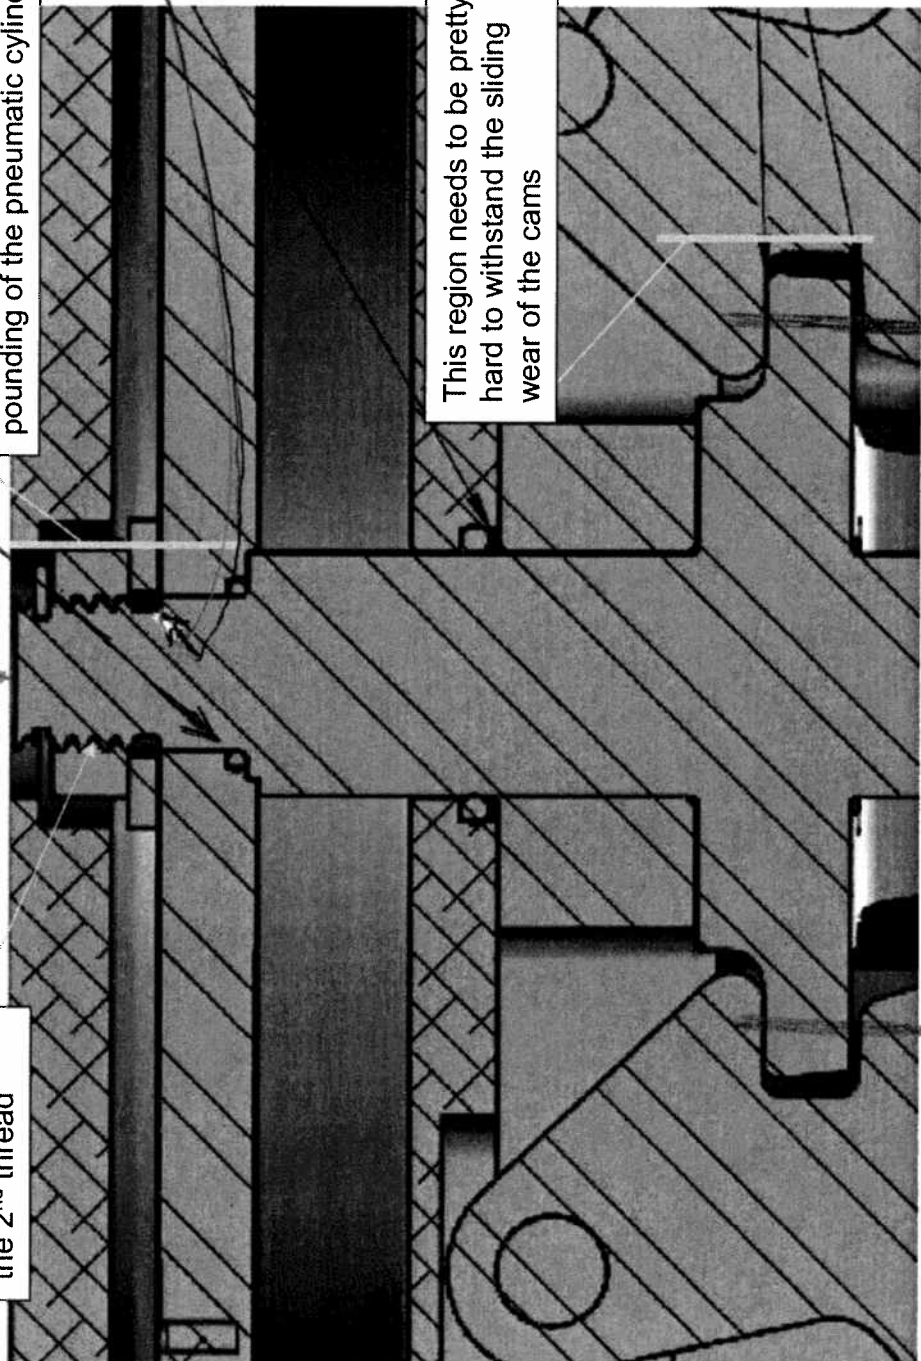
CAN THIS BE
BROUGHT STRAIGHT
DOWN? (REDUCES
SPRING CONSTANT
ENDS?)

SEAL?

Failure occurred
here, at the root of
the 2nd thread

THREAD HERE?

This region needs to be pretty
tough to withstand the tensile
pounding of the pneumatic cylinder

This region needs to be pretty
hard to withstand the sliding
wear of the cams

← AIR
GAP?
IS THIS A
PRESSURIZED
AREA?

THIS CORNER MAY
CONTRIBUTE TO
STRESS CONCENTRATION
AT THREAD ROOT.

IS THIS
PLATE IN
BENDING?

YOU WANT
TO PREVENT
ROTATION
HERE. MAKE
PLATE DEEPER
AT SHAFT

✓ CAMS PRODUCE
AXIAL LOAD HERE?
